**City of Kingston**  
**Report to Heritage Properties Committee**  
**Report Number HP-24-012**

**To:** Chair and Members of the Heritage Properties Committee  
**From:** Jennifer Campbell, Commissioner, Community Services  
**Resource Staff:** Kevin Gibbs, Director, Heritage Services  
**Date of Meeting:** February 21, 2024  
**Subject:** Application for Heritage Permit  
**Address:** 47 Wellington Street (P18-386)  
**File Number:** File Number: P18-096-2023

An application for alteration under Section 42 of the *Ontario Heritage Act* (P18-096-2023) has been submitted to support a total of 17 condominium units for the entire property by building a rear yard, four-storey flat-roofed addition with an associated service elevator that will attach to the existing schoolhouse. This application was deemed complete on January 4, 2024. The *Ontario Heritage Act* provides a maximum of 90 days for Council to render a decision on an application to alter a heritage building under Section 42(4). This timeframe will expire on April 3, 2024.

**City File**

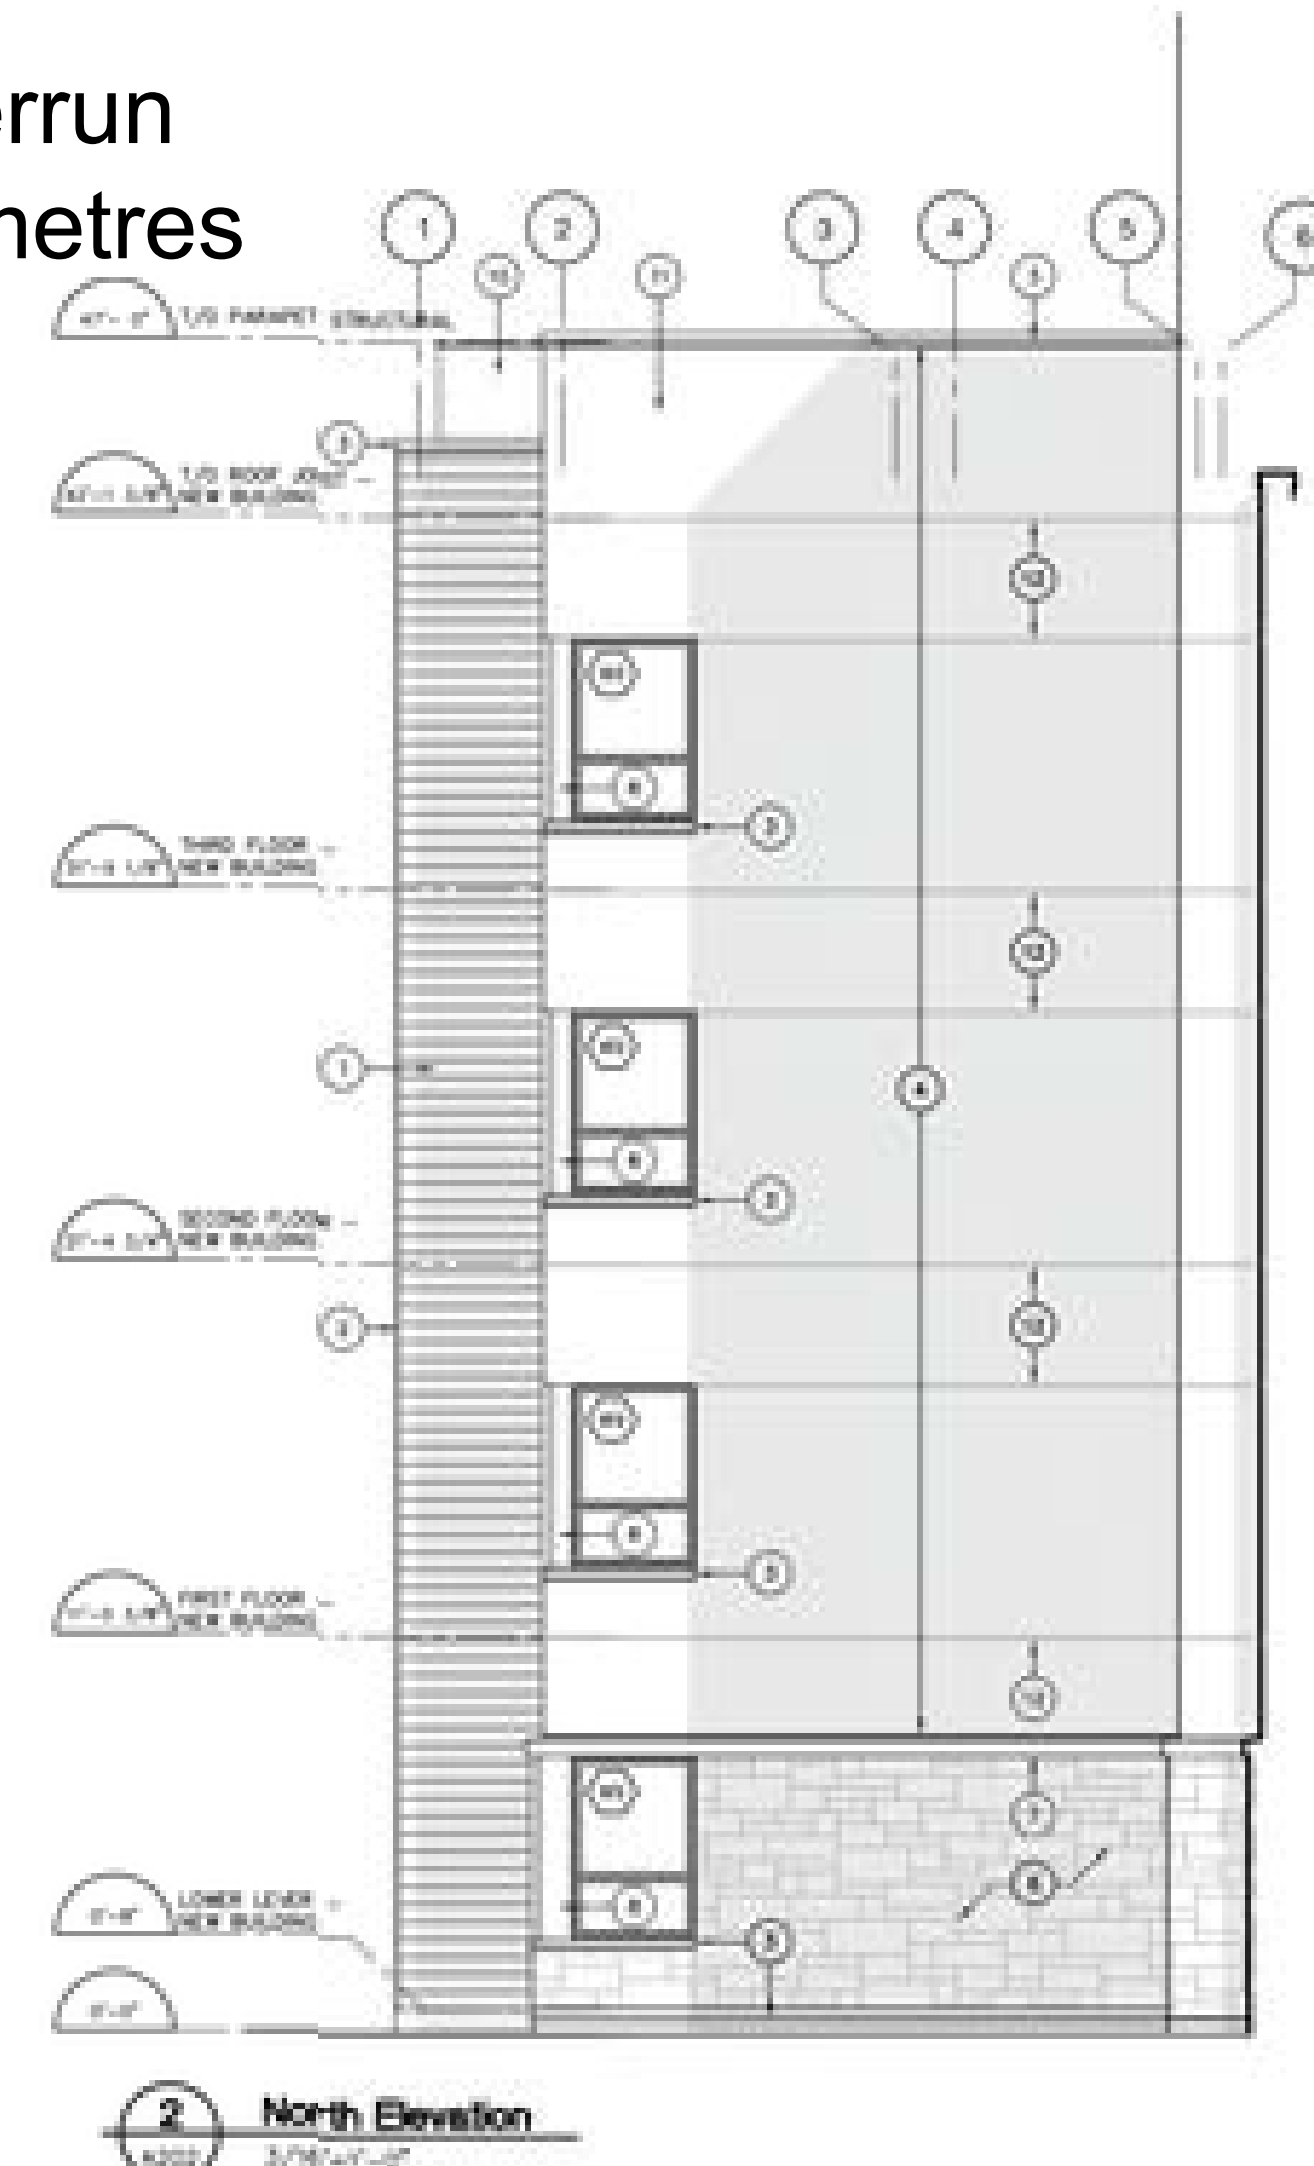
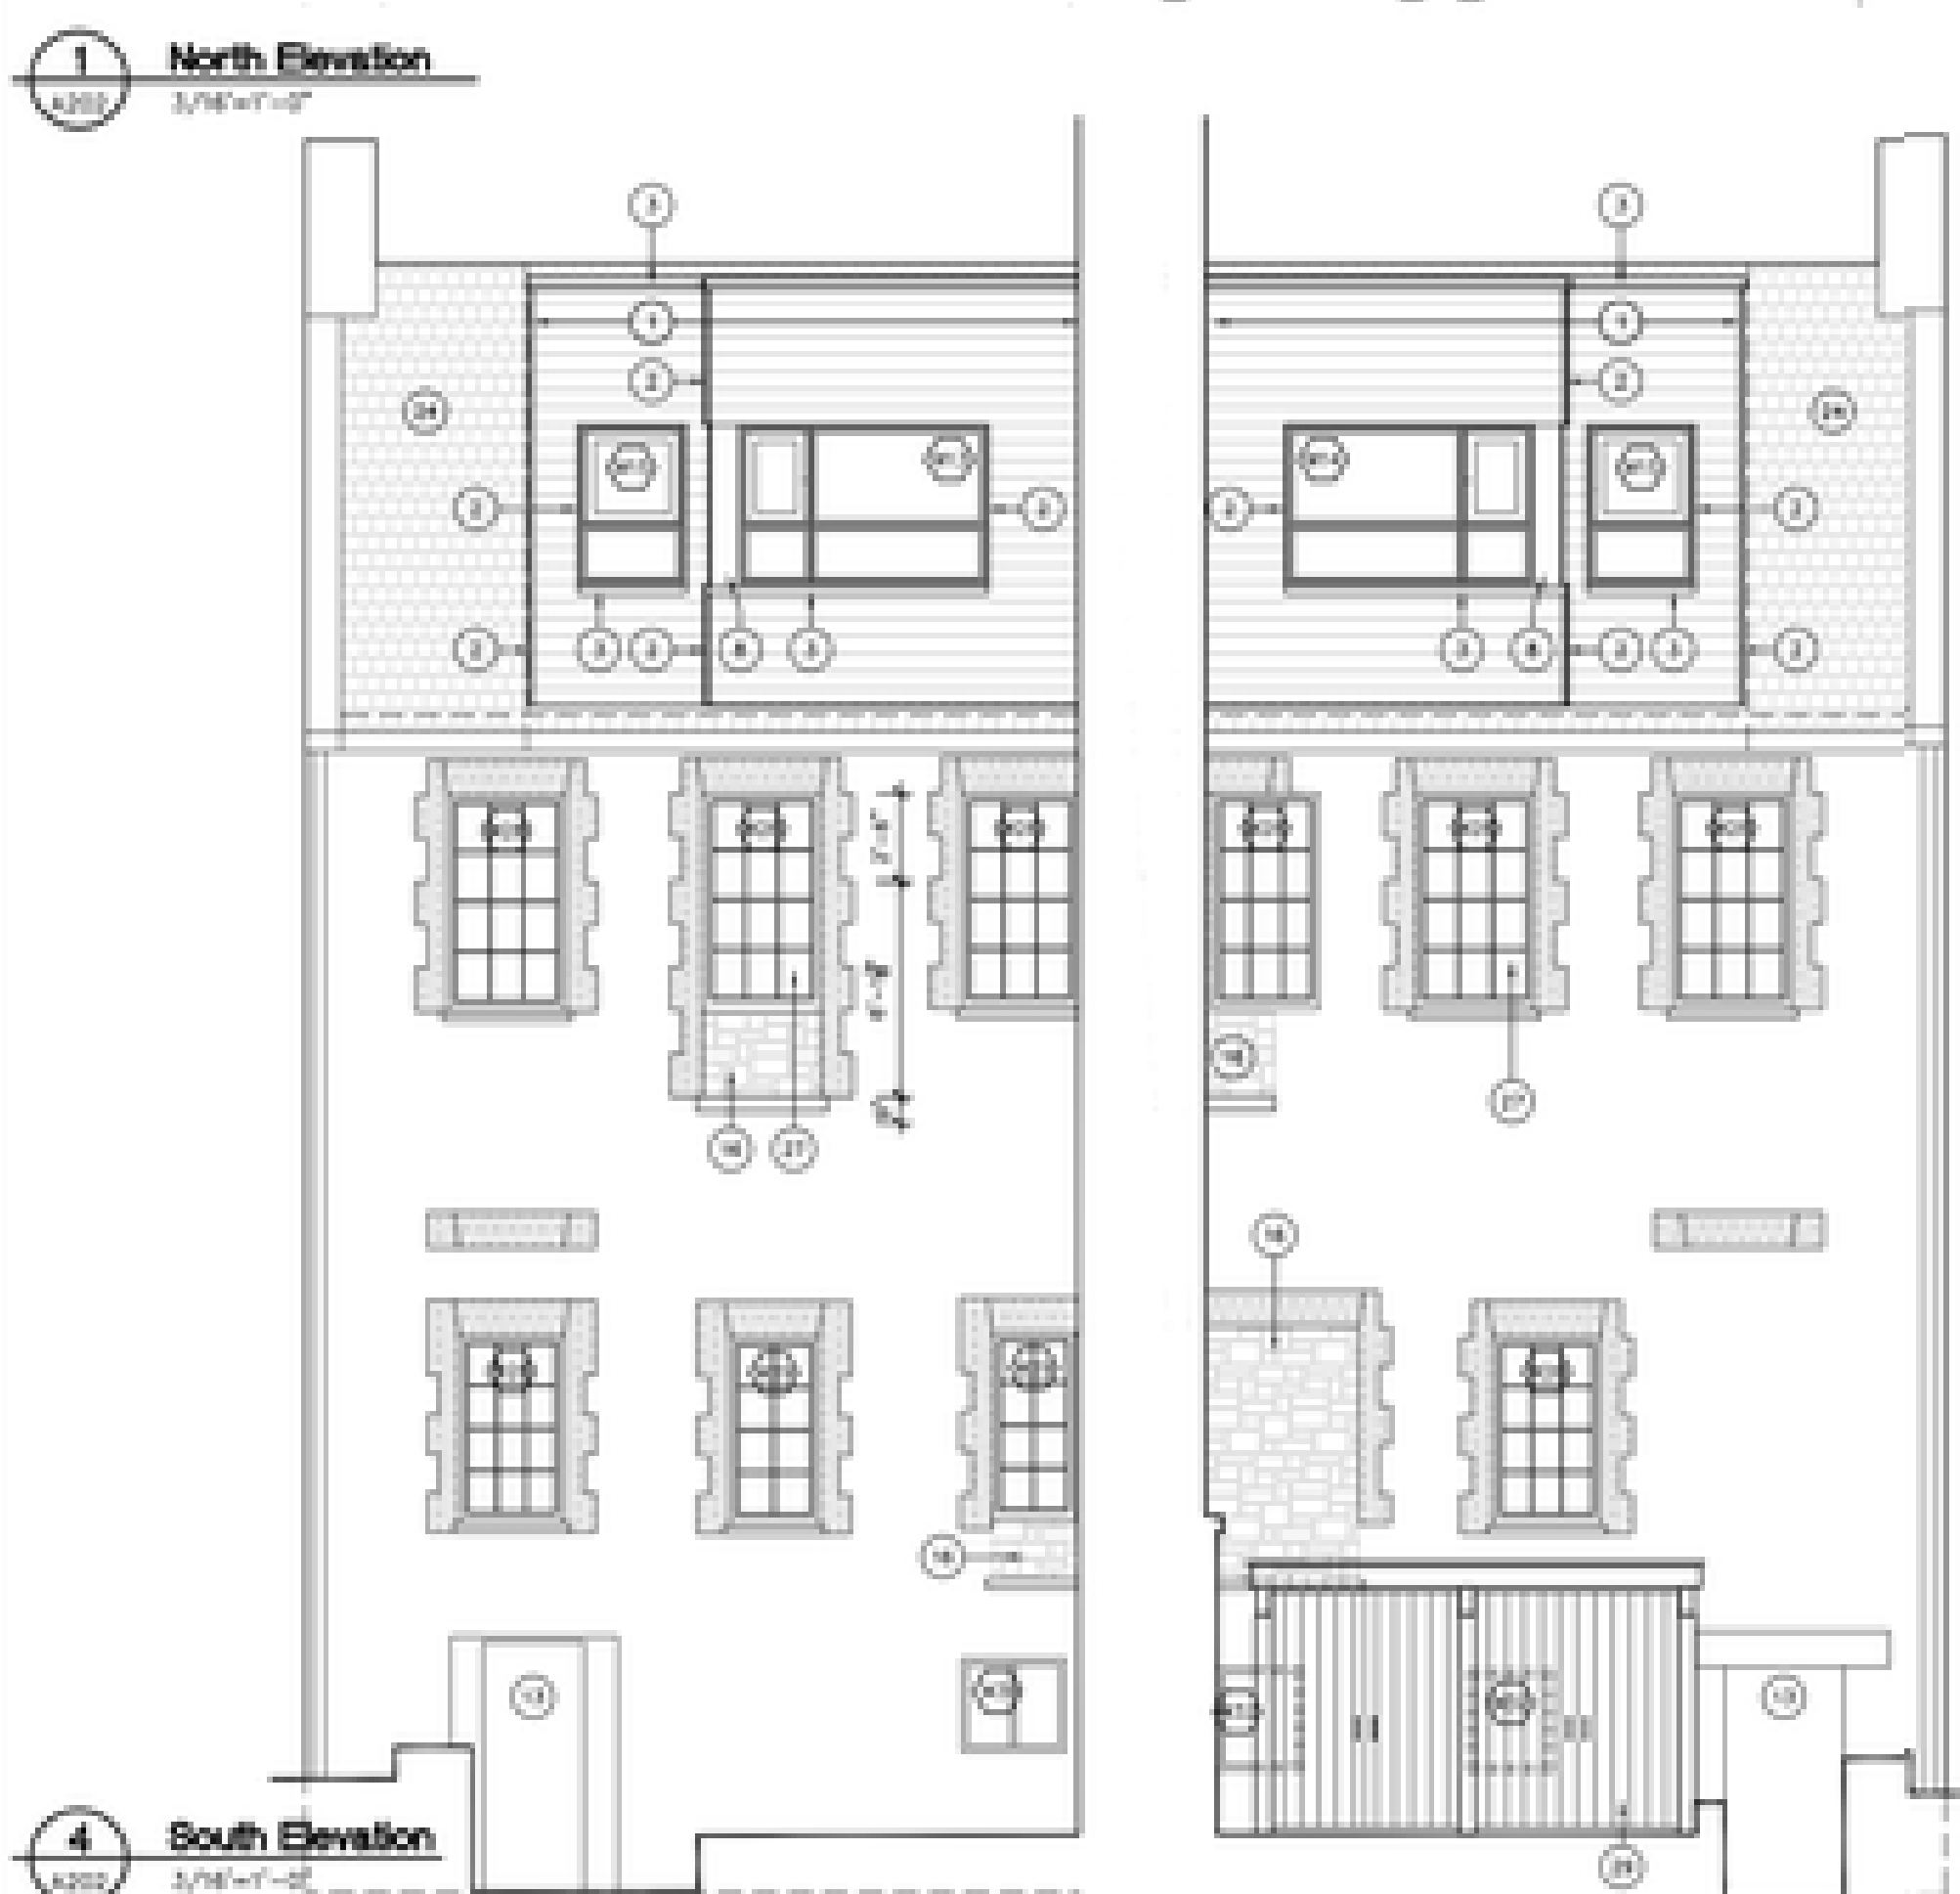
Height of elevator overrun reduced by 0.5-0.75 metres
